No. PLW/E/Drg/Loco/EL-101 (Brake Gear)

**Sub:- Implementation of RDSO Modification Sheet for modification in tie bar & its safety sling bracket of conventional brake rigging arrangement equipped in WAP-7 and WAG-9HC three phase electric locomotives.**

**Modification Sheet No. RDSO/2025/EL/MS/0513, Rev. '0' Dated: November' 2025**

Modification in Tie-bar for all axle locations & its safety sling bracket for axle no. 2, 3, 4 & 5 of conventional brake rigging arrangement equipped in WAP-7 and WAG-9HC three phase electric locomotives.

**Fig.-3** Modified Tie-bar arrangement

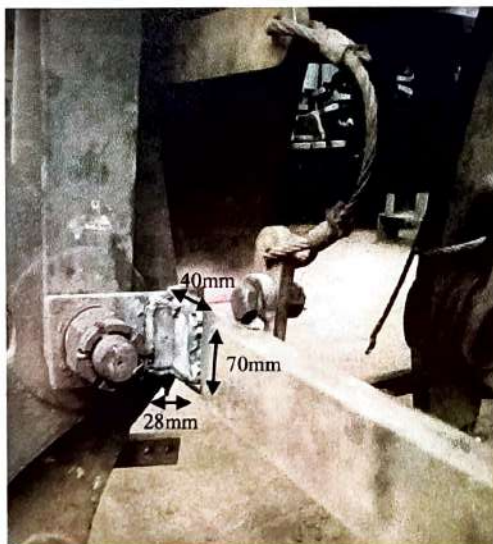
In the existing brake rigging arranging as shown in fig.-1 & 2, Safety sling bracket of Tie-bar has been welded on hanger. The bracket, which is fixed to the brake hanger assembly, is subjected to repeated impacts as the brake hanger assembly hits the bracket during every operation, causing the bracket to break.

Weld an additional MS plate of 'L' shape having dimension of height -70mm, length-40mm, width-28mm & thickness-06mm at the end of Tie-bar and its safety sling bracket for axle no. 2, 3, 4 & 5 on bogie as shown in fig.- 3 & 4. Safety sling bracket shall be welded in same vertical line to Tie-bar bracket. The welding shall be done at appropriate location by MIG welding. The welding procedure and inspection/testing of weld quality shall be done in accordance with the procedure laid down in RDSO specification no. VL. SPEC-6 rev '3' (Technical specification for fabricated bogie frame & bolster assembly for locomotives).

12 nos. of MS plate of 'L' shape of height -70mm, length-40mm, width-28mm & thickness-06mm
